DATE: September 19, 1996
TO: Chris Brown- USI RC
FROM: Gyo Shinozaki 
RE: Response to phone conversation

The following pages are Hochiki America's responses to the phone conversation we had on September 17th. The first section titled "Revision to Application" contains italicized statements. These are either additions or revisions to the Quality Control section of our June 7th application (pages 5 through 7). The second section titled "Clarification of Issues" refers to the tamperproof outer cover for the AIE type detector and the equivalent of CPM to curies.

1) REVISION TO APPLICATION:

2) CLARIFICATION OF ISSUES

9 - 1383
UNDERWRITERS LABORATORIES INC.
LISTED
AUTOMATIC FIRE DETECTION BASE
FOR OPEN AREA PROTECTION
ISSUE NO. A-1748
WHEN USED WITH A HOCHIKI AMERICA
UL LISTED DETECTION HEAD

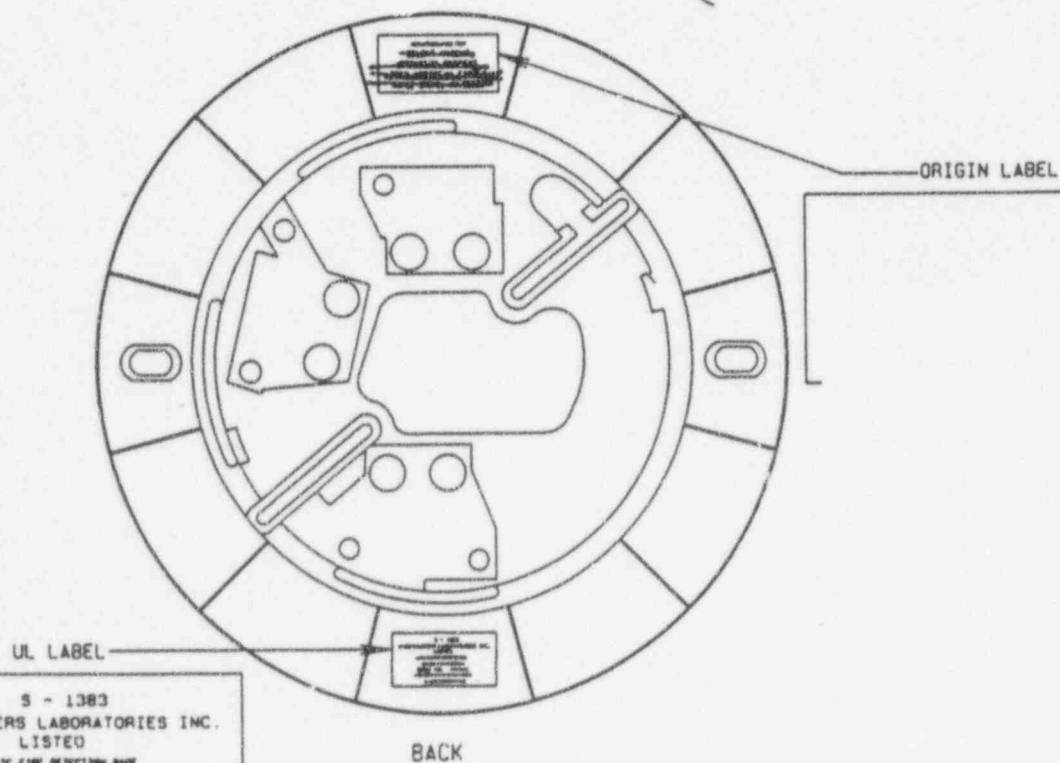
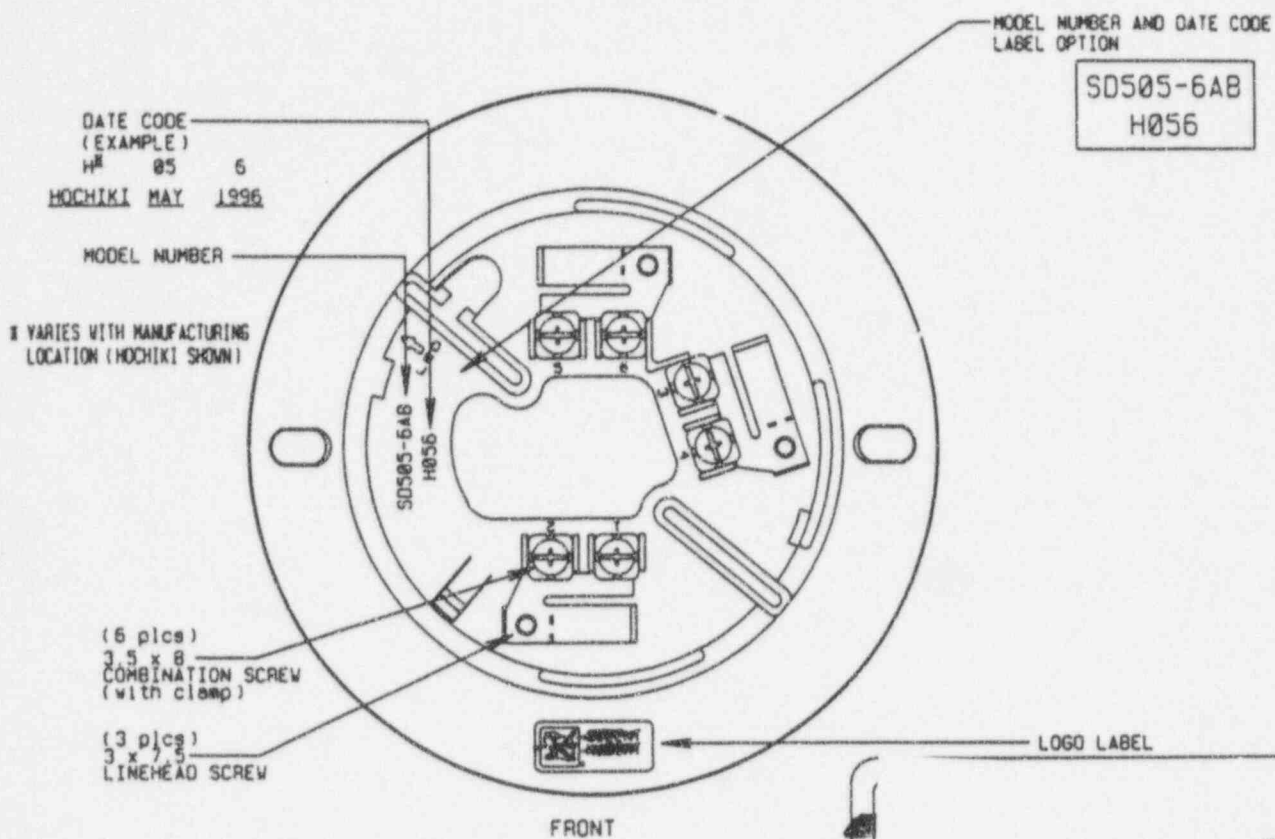
The AIE type detector is different from most units in that it does not require removal of the Outer Cover in order to attach it to a ceiling etc. This is achieved through the use of a separate base device in which the detector is attached. The base unit is mechanically attached to the ceiling etc. There is both a mechanical connection and electrical continuity via the use of metal fittings. These base units will vary dependent upon the application in which it is used. *A drawing of a typical base unit is enclosed.*
